**Commonwealth Edison**

October 27, 1980

Subject: LaSalle County Station Unit 1 and 2  
Response to INFORMAL NRC Questions  
Concerning In-Plant S/RV Test Plan  
NRC Docket Nos. 50-373/374

Figure 6.1 LaSalle Suppression Pool Showing RHR Loop A in Operation

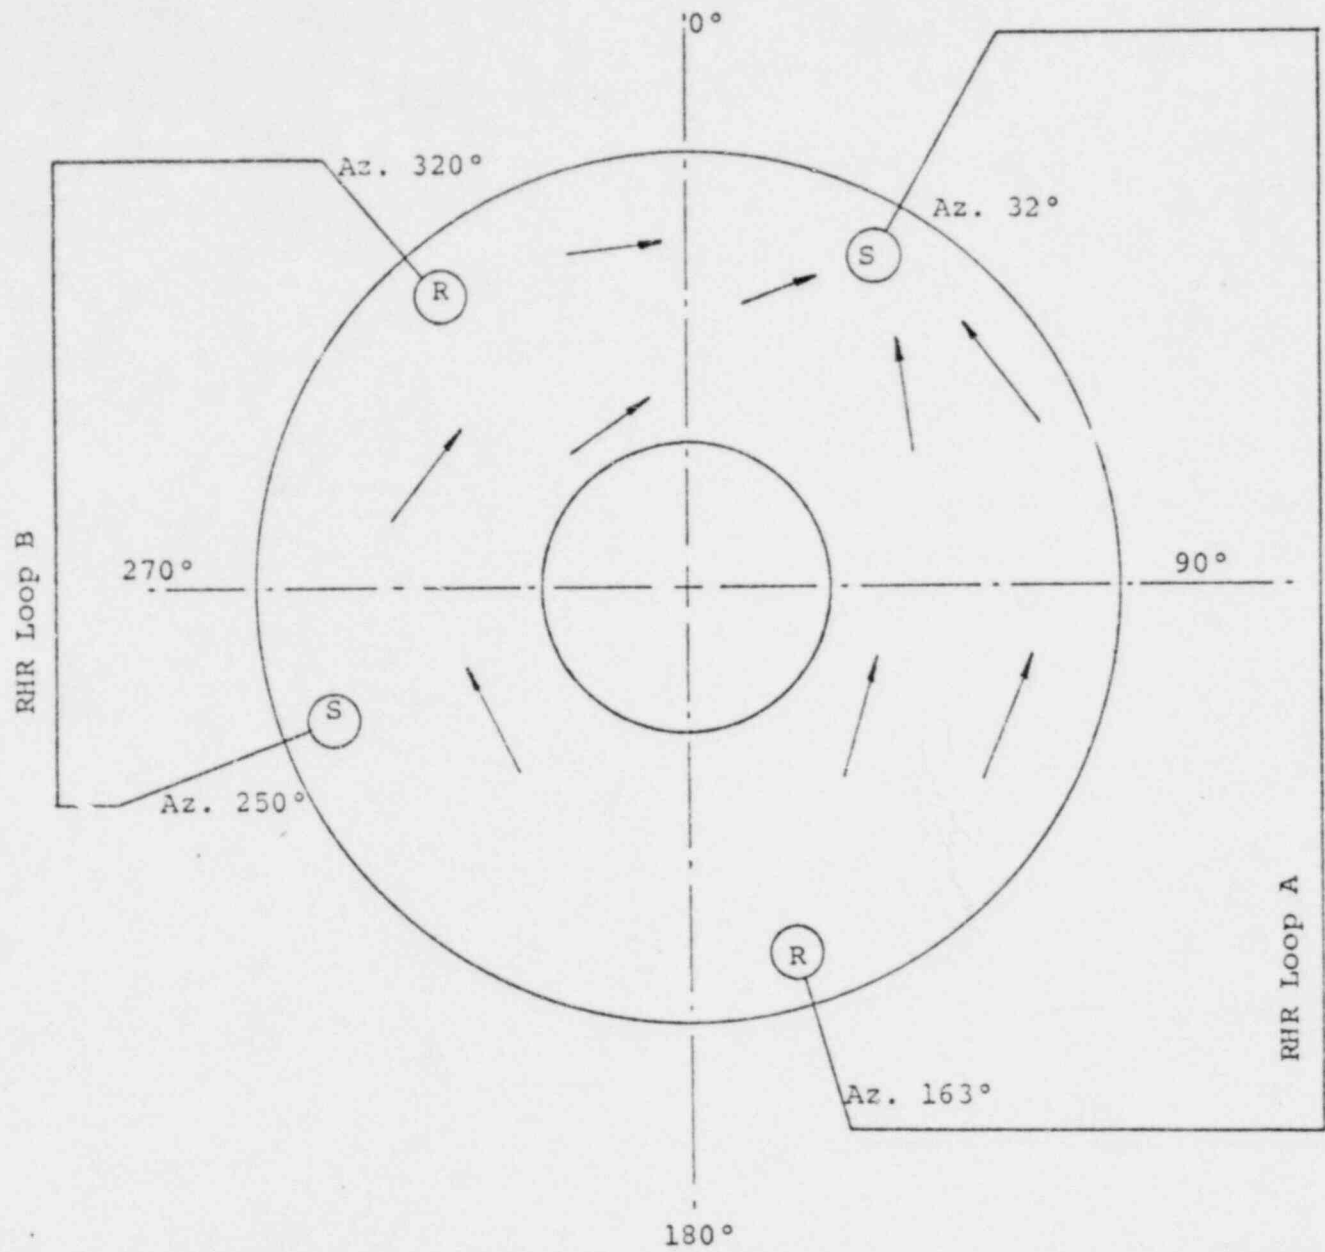
Describe the orientation of the quenchers with respect to the direction in which steam exits from the end cap perforations. Also indicate the direction of pool swirl with the RHR in operation. The acceptability of the temperature sensor array described in the test plan depends on this information. For example if the swirl is counterclockwise (as viewed in Figure 14 of the test plan) the array is acceptable, otherwise it is not.

The T-quenchers in the LaSalle plant are located at two radii as shown in Figure 16 of the Test Plan document (Revision 3). The longitudinal axis of all T-quencher arms are oriented in a circumferential direction such that the end cap holes allow flows to exit in the clockwise direction when viewed from top.

During the in-plant SRV test, two sets of extended blowdown tests will be performed. One test will be performed without any RHR system in operation, while another test will be performed with RHR Loop A in operation. The swirl in the pool due to the operation of RHR Loop A will be caused by the pump suction, which is located at azimuth of  $32^\circ$ , and the return line, which is located at azimuth of  $163^\circ$ . With this orientation, the RHR suction of Loop A will draw pool water from both sides as shown by arrows in Figure 6.1. Therefore, in the test zone, which is located between azimuths  $180^\circ$  and  $270^\circ$ , the swirl in the suppression pool due to RHR Loop A will be clockwise, whereas the flow in the sector between azimuths  $0^\circ$  and  $180^\circ$  will be counterclockwise.

Notwithstanding the clockwise direction of the T-quencher end cap flows, the RHR Loop A would have a significant influence in determining the swirl pattern in the suppression pool as well as the columns which act as baffles causing directional changes in the flow. Furthermore, the mass flow rates exiting through the holes on the T-quencher arm which will be in a radial direction, unlike the circumferential direction of the end cap holes, are

much larger and will cause turbulent mixing of pool water in the vicinity of the T-quencher. Therefore, the suppression pool water is unlikely to experience a "clean swirl" in any given direction; rather the flow pattern will be turbulently mixed in the vicinity of the T-quencher with the general flow pattern moving toward the RHR Loop A suction line due to the operation of that system. The extensive network of temperature sensors installed on the pedestal wall, containment wall, basemat, and columns are adequately distributed to measure the pool temperature distribution resulting from this flow pattern.

Based on the foregoing discussion, it is our opinion that the current temperature sensor locations are adequate for determining the effects on thermal mixing during an extended blowdown test. We appreciate the concern raised by this question; however, we feel that a "clean" unidirectional swirl is not likely to occur and hence any relocation of sensors is unwarranted.
